# SERVICE BULLETIN

SP2020-001  
Revision 0  
December 22, 2020

## Relay Replacement Kit

**Affected Products:** Control panels and relay boards using relay 444011.  
**Affected Serial Range:** N/A  
**Related Issue #:** N/A

**NEMA  
IEC**

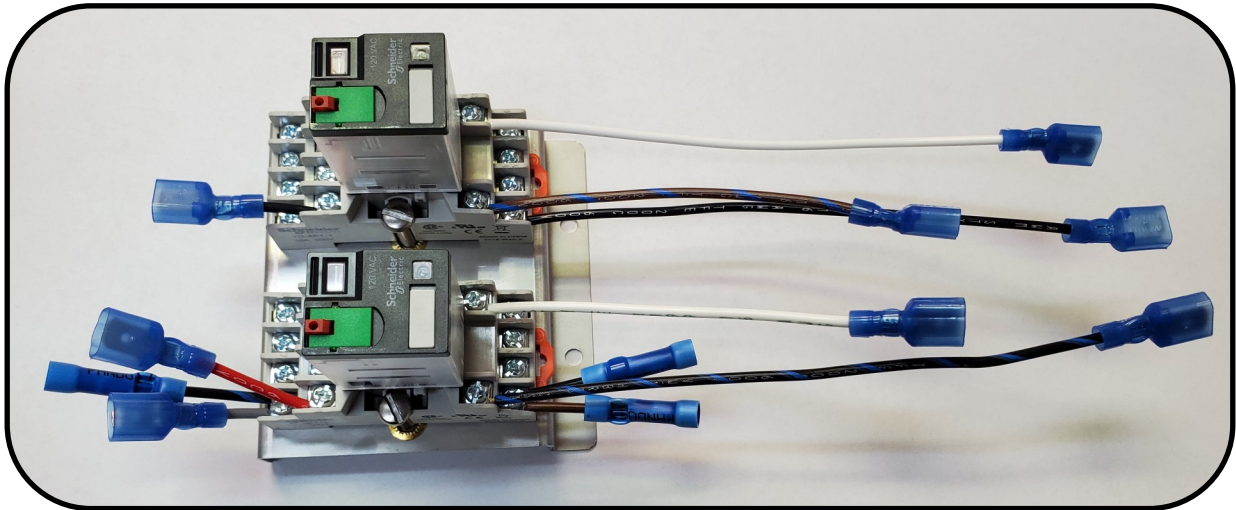
Relay 444011 was discontinued by the manufacturer and has been replaced with relay 444023 and socket 444024 in gas rotisserie smokers (see Product Bulletin SPProd-025). When relays 444011 need replaced, the following replacement kits can be purchased for an easy transition.

The new relay and socket assembly will attach to the control panel or relay board in place of the old relays.

On smokers with color-coded wiring harnesses, the wire leads on the sockets will connect to the same color wires removed from the old relays. On smokers without color-coded wiring harnesses, careful attention will need to be paid to the position of the wire on the old relay to match up with the correct position on the new socket.

Corresponding Positions	
Relay	Socket
1	4
2	12
3	8
4	12
A	13
B	14

495009 Shown Below

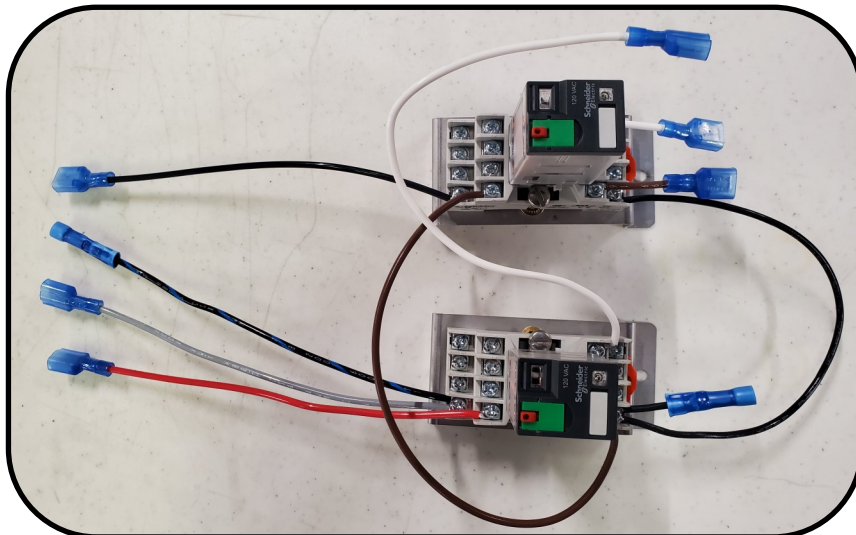
All but a few wires will be disconnected from the old relays and reconnected to the corresponding wire leads on the new sockets using the existing quick disconnects. A few wires are connected to the old relays using piggyback disconnects. On those wires, the piggyback disconnect will need to be cut off and the wire stripped and crimped into the appropriate butt splice connector on the new socket. Jumper wires between terminals on the old relays can be discarded.

The two relays control the door interlock switch/proximity sensor and the smoke extractor/VSP hood system. **The relay for the smoke extractor/VSP hood system has a red wire, while the other relay does not.**
